# Book 23

## Witness Statement of H. Robert Rimrott

## Hidden Quarry

Re: Response to Peer Review from Novus Environmental Inc. for Proposed Hidden Quarry in Rockwood, Ontario, dated April 8, 2013.

Drawing Title:  
 Daytime Sound Level Contours @ 4.5m Height  
 Phase 3, Stage 2

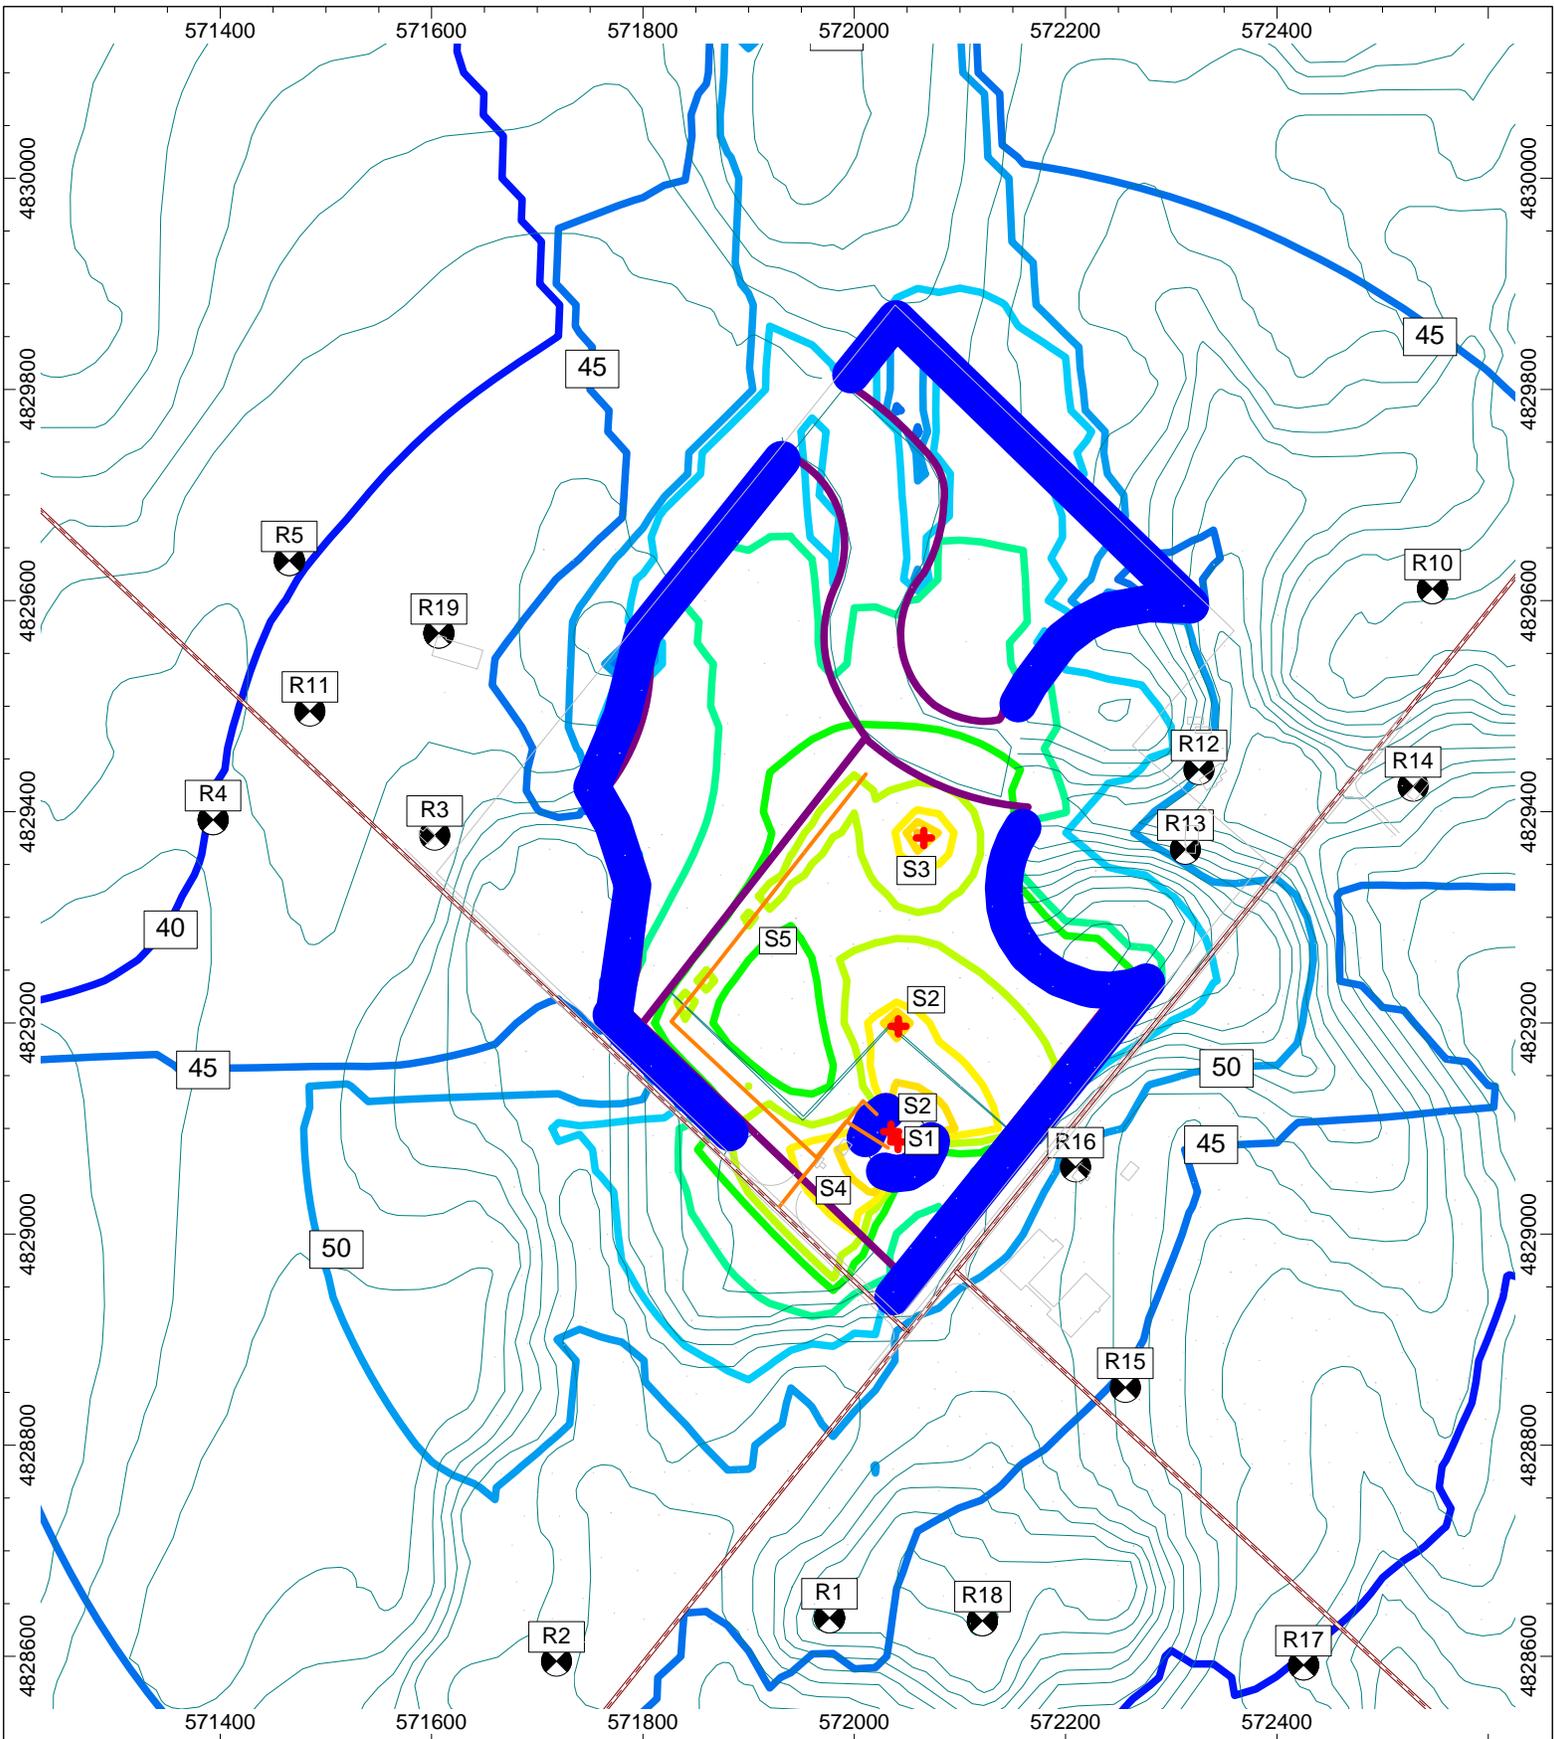
*The AEL report notes that a receptor height of 1.5m was used in the assessment. This is inconsistent with both MOE NPC-205 and NPC-232 noise guidelines*

*The report does not indicate where source equipment is being located within the quarry for noise modelling purposes. A contour map is required to confirm that compliance is achieved at all points at ground level within 30m of dwellings.*

Although Aercoustics disagrees with Novus' interpretation of the MOE guidelines with respect to daytime receptor heights, Aercoustics has verified that impacts from daytime quarry operations at a 4.5m receptor height for two-storey dwellings does satisfy the established daytime sound level limit criteria, with the implementation of the acoustic controls as recommended in our Noise Impact Study<sup>1</sup>.

Night time operations were assessed at a 4.5m receptor height as part of our report for residences which have a 2<sup>nd</sup> storey, however a clerical oversight resulted in 1.5m night time sound levels being reported for *all* receptors. This has been addressed in an updated report.

Aercoustics has attached sample daytime contours to this letter, generated at 4.5m, to validate the claims made in item 1 above.

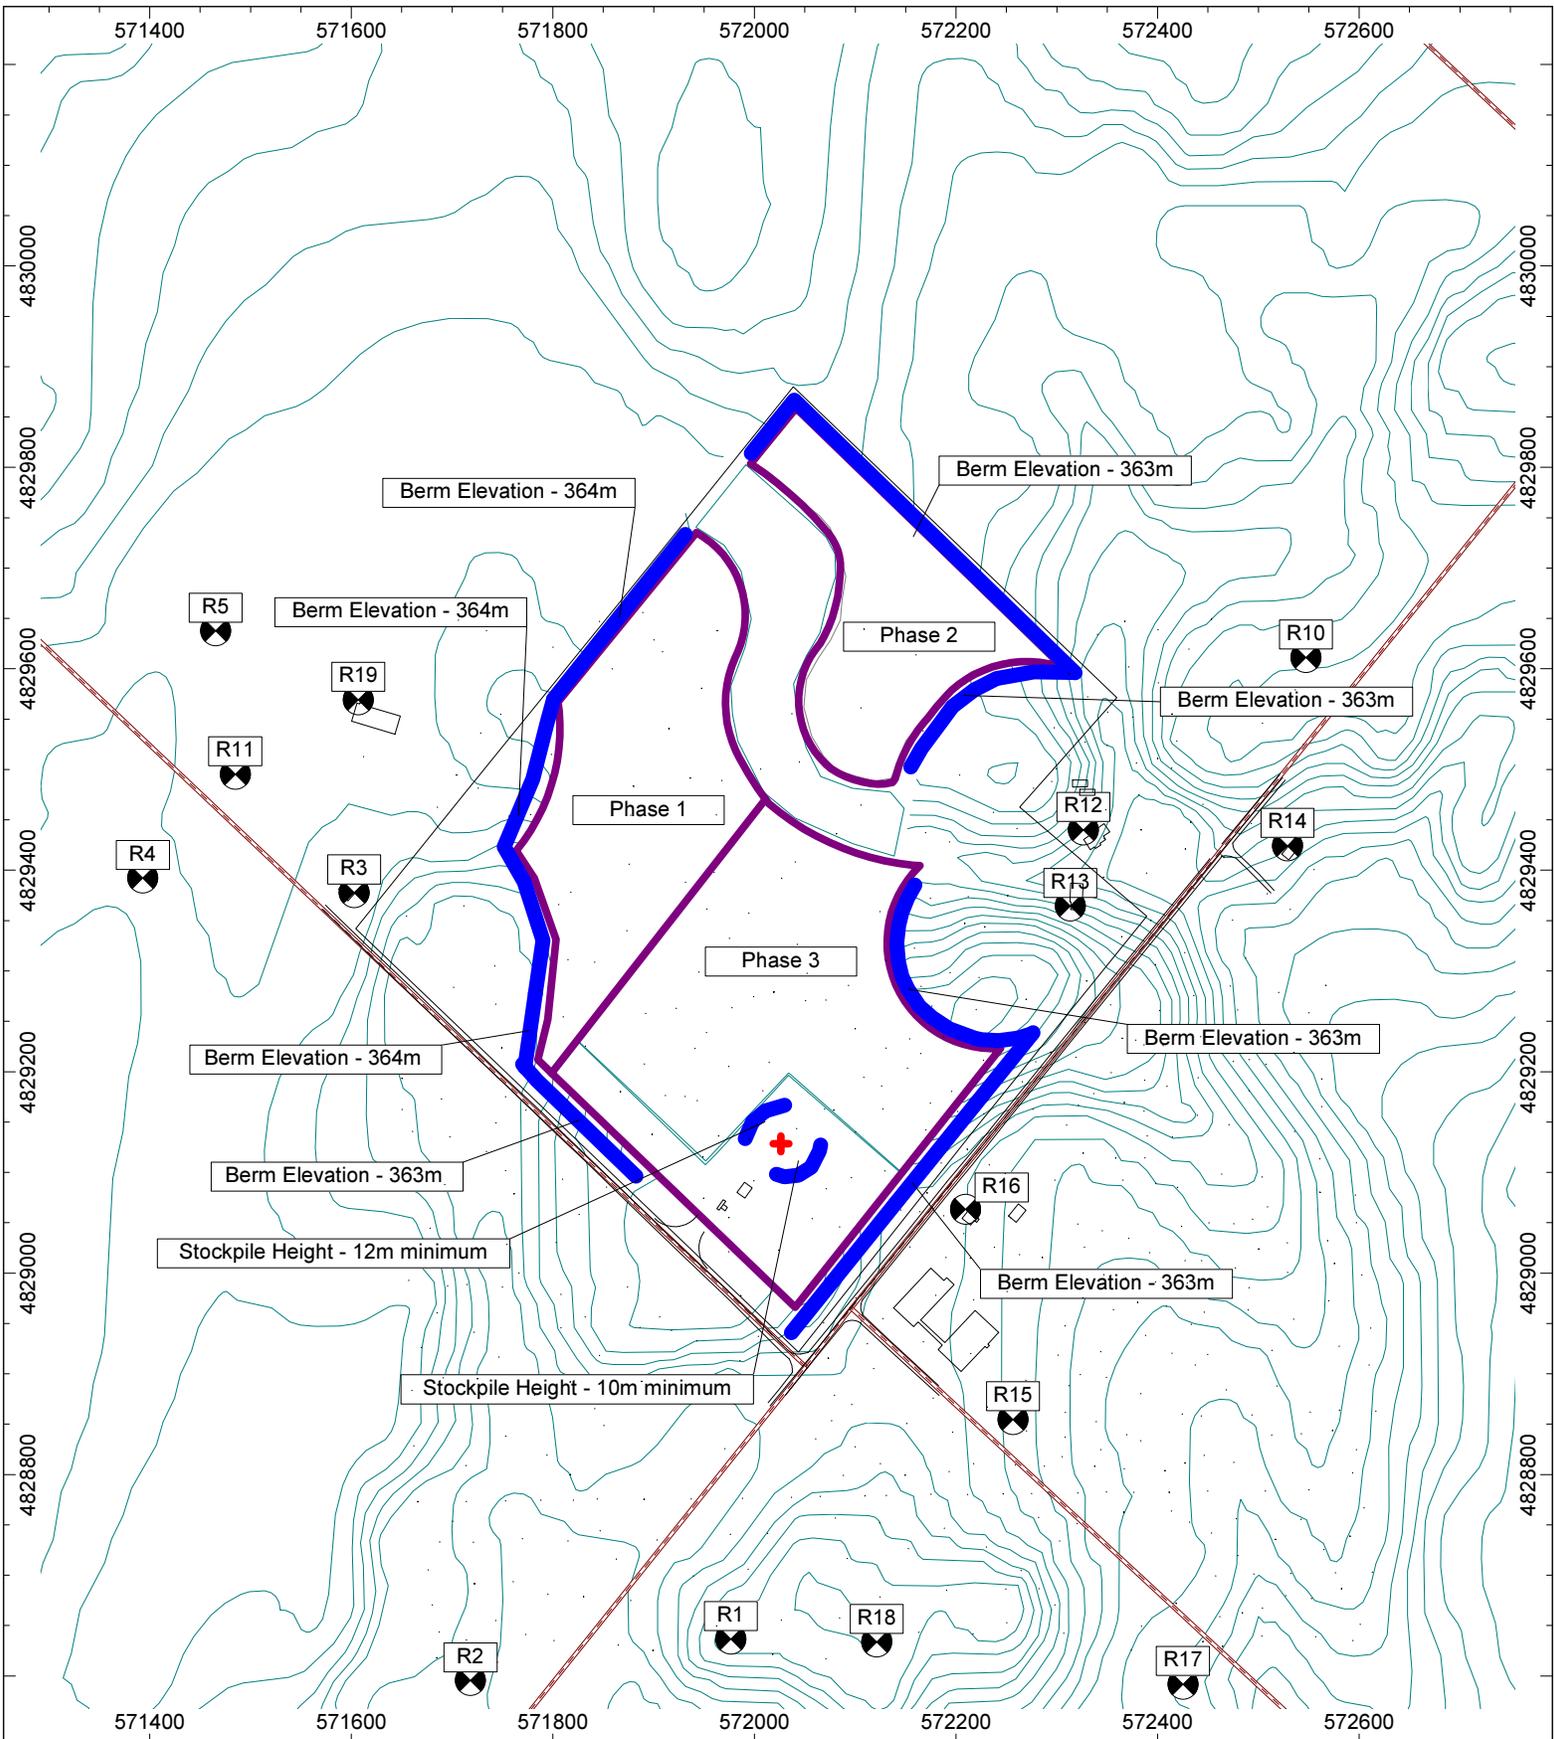
1. Revised quarry floor elevation height for high spring water elevation level  
The high spring water level was measured to range from 346 masl to 354 masl across the site as shown in Figure 1. In the vicinity of the process plant location the high spring water level elevation is around 350 masl.

A revision to the noise model was required to accommodate the quarry floor remaining above the high water table, specifically in the processing plant area where the quarry floor has increased from 349 masl to 351 masl. The noise model used conservative quarry floor levels of 355 masl in phases 1 and 3 and 354 masl in phase 2.
2. Changes to on-site truck haul routes for phases  
On-site truck haul routes for Phases 1, 2 and 3 have been updated based on the latest site plan.
3. Updated location of processing plant and stockpile locations  
A minor reposition of the processing plant and stockpiles was implemented in the model to reflect the location shown on the latest site plan.

- 1) Quarry floor in the vicinity of the processing plant was changed from 349 masl to 351 masl.
- 2) The east portion of the 12 m stockpile shown on the site plan adjacent to the processing plant was extended to provide screening for R7.
- 3) Removal of recommendation for direction of extraction. There is no requirement to use the working face as a noise control measure. Perimeter berming is will provide sufficient screening.

This configuration is shown in Figure 2.
